December 2, 2016
Serial: HNP-16-066

Shearon Harris Nuclear Power Plant, Unit 1
Docket No. 50-400/Renewed License No. NPF-63

Subject: License Amendment Request to Relocate Technical Specification Cycle-Specific
Parameters to the Core Operating Limits Report

PROPOSED TECHNICAL SPECIFICATION CHANGES
SHEARON HARRIS NUCLEAR POWER PLANT / UNIT 1

FIGURE 2.1-1
REACTOR CORE SAFETY LIMITS – THREE LOOPS IN OPERATION
WITH MEASURED RCS FLOW > [293,540 GPM X (1.0 + C₁)]

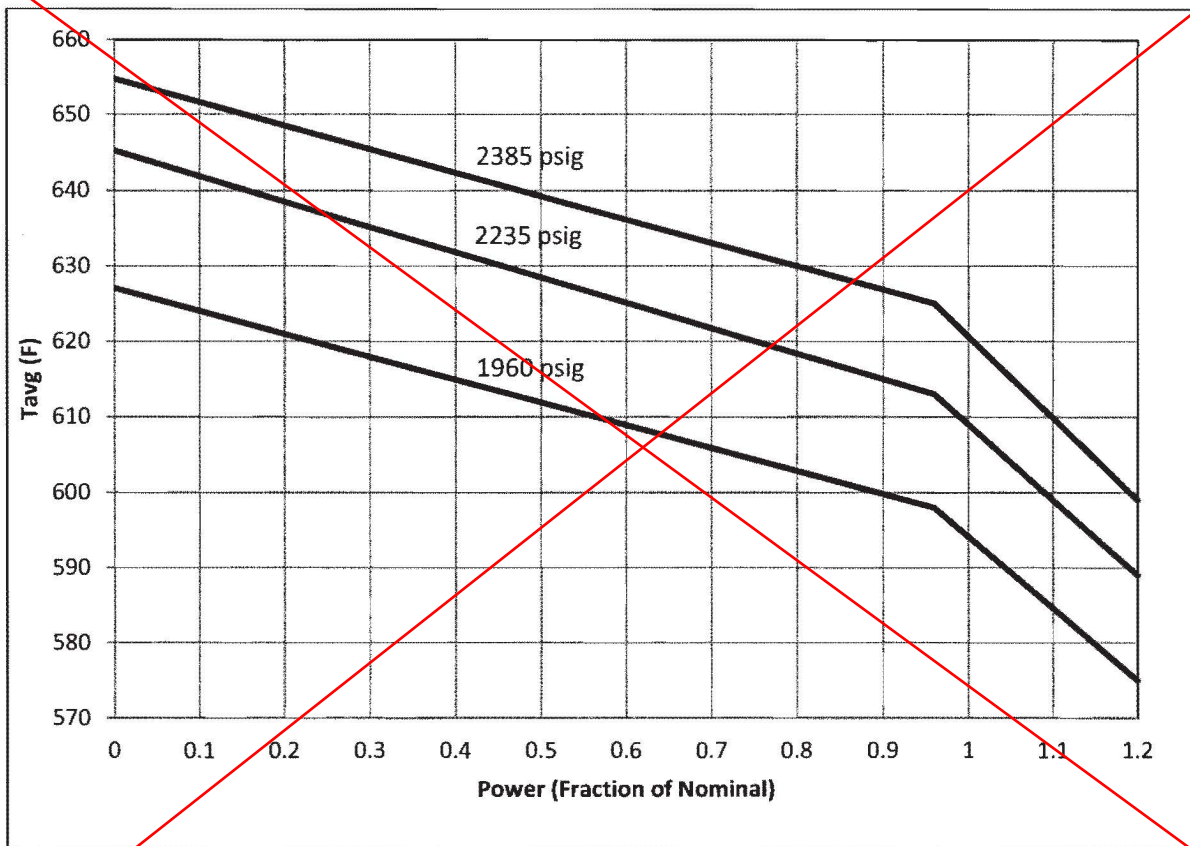
- TS Figure 2.1-1 is deleted and relocated to the COLR.
- TS Safety Limit 2.1.1 is revised to read:
 - 2.1.1 The combination of THERMAL POWER, pressurizer pressure, and the highest operating loop coolant temperature (T_{avg}) shall not exceed the limits specified in the COLR; and the following Safety Limits shall not be exceeded:
 - a. The departure from nucleate boiling ratio (DNBR) shall be maintained ≥ 1.141 for the HTP DNB correlation.

2.1.1 The combination of THERMAL POWER, pressurizer pressure, and the highest operating loop coolant temperature (T_{avg}) shall not exceed the limits ~~shown in Figure 2.1-1 for 3-loop operation.~~

ADD:
"This figure is deleted from Technical Specifications and relocated
to the COLR."

specified in the COLR; and the following Safety Limits shall not be exceeded:

- a. The departure from nucleate boiling ratio (DNBR) shall be maintained ≥ 1.141 for the HTP DNB correlation.
- b. The peak centerline temperature shall be maintained $< [(2790 - 17.9 \times P - 3.2 \times B) \times 1.8 + 32] ^\circ\text{F}$ where P is the maximum weight percent of Gadolinia (%) and B is the maximum pin burnup (GWD/MTU).
